**RE: Status Update - Removal Action Decision  
Congaree River Sediments  
SCE&G Huger St. VCC #02-4295-RP  
Columbia, South Carolina**

The intent of this letter is to provide a status update regarding the Congaree River Sediment Removal project located in Columbia, South Carolina. More specifically, it is to document the problems and concerns identified during review of the current design via the permitting process with the regulatory agencies. As discussed at the meeting on January 14, 2015, the problems and concerns are directly related to how the selected removal action alternative was going to be implemented (i.e., installing a stone-filled cofferdam in phases to isolate the known occurrence of tar-like material [TLM] to facilitate removal).

FIGURE 3  
 SOUTH CAROLINA  
 ELECTRIC & GAS COMPANY

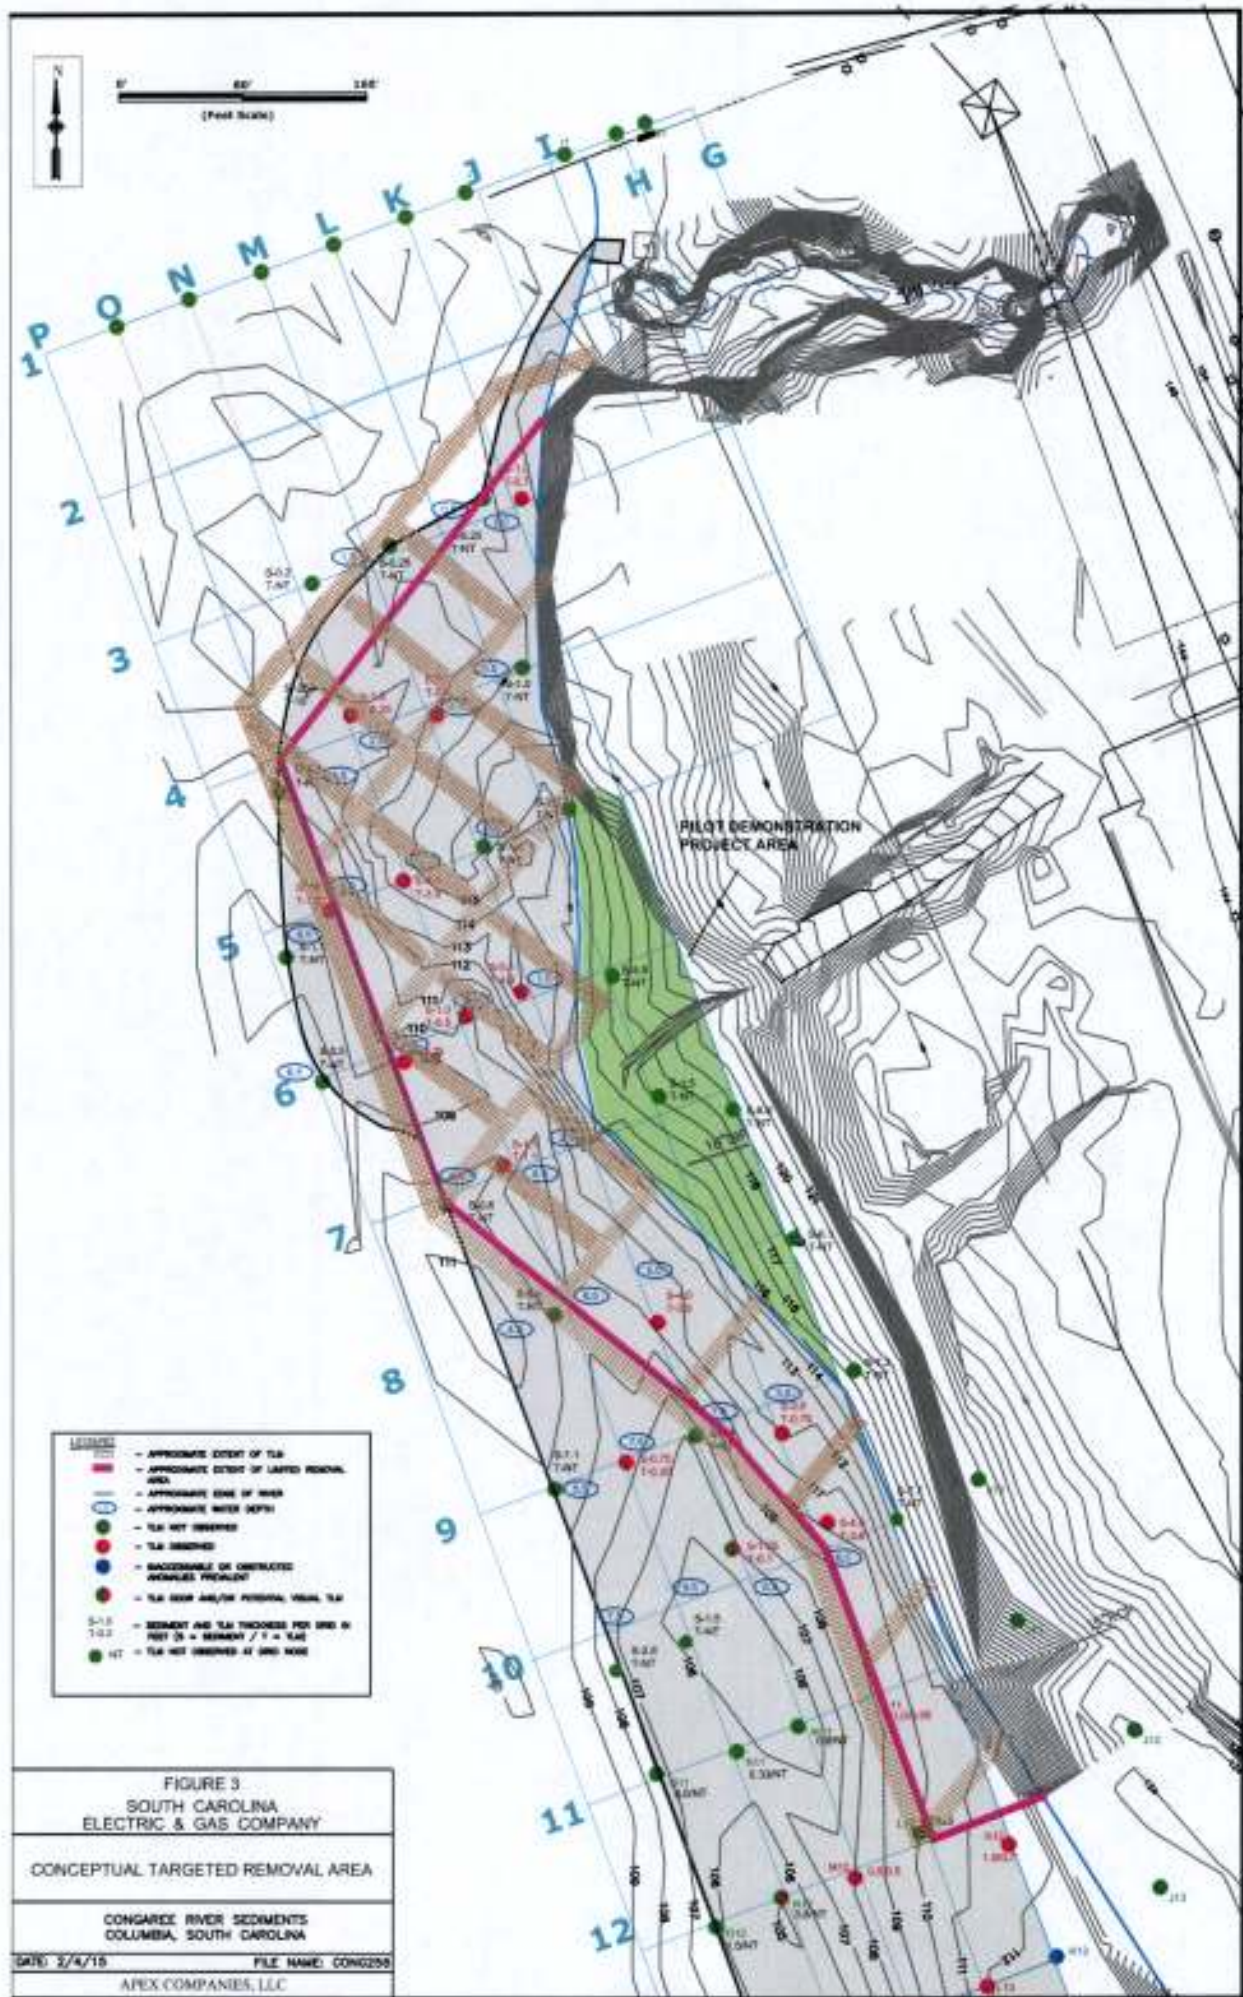
In reconsidering the removal alternative and in preliminary discussions between SCDHEC, USACE and SCE&G, a new approach that consists of a “Modified Removal Action” is emerging. The preliminary, conceptual approach is shown on Figure 3. Based on the EE/CA, the removal action alternative provides the best overall protection of human health and the environment, when compared to the other alternatives. From an environmental regulatory perspective, there is a preference for completing a removal action as opposed to the other alternatives. Given the concerns and limitations discussed above, a Modified Removal Action is a prudent approach that will accomplish multiple objectives, while potentially reducing or eliminating the negative attributes associated with the “large” cofferdam approach.

The revised Removal Action will consist of removing TLM-impacted material from “targeted” areas of the site. The areas to be removed will generally consist of the thicker deposits of impacted material that are generally located closer to the existing eastern shoreline (e.g., the boat launch area and the alluvial fan area). These are areas where potential human contact has a greater likelihood of occurring. The extent of the area to be removed is shown on Figure 3 but may change during the design and permitting process. Overall, the Modified Removal Action will be somewhat smaller than the original two-phase cofferdam approach because it is limited by the constraints of working in the River. The previous Phase 2 area, which created the highest backwater effect in the modeling discussed above, would be eliminated

from the proposed removal action area. Implementation of the Modified Removal Action will likely be completed using large sand bags or some other temporary means to isolate the work area. For presentation purposes, isolation and dewatering of a 50 by 100 foot area using large sand bags is depicted on Figure 3. The actual methods for isolating the removal "cells" will be determined in the design phase and incorporated into permit submittals. Many of the existing support plans will still be applicable and only require minor revisions.

SCE&G requests SCDHEC's approval to revise the scope of the Removal Action alternative currently reflected in the design and permit documents. In its place, a Modified Removal Action Plan will be developed as described above and submitted for SCDHEC review and approval. As with the original approach, there will be numerous design and permitting tasks that need to be completed.
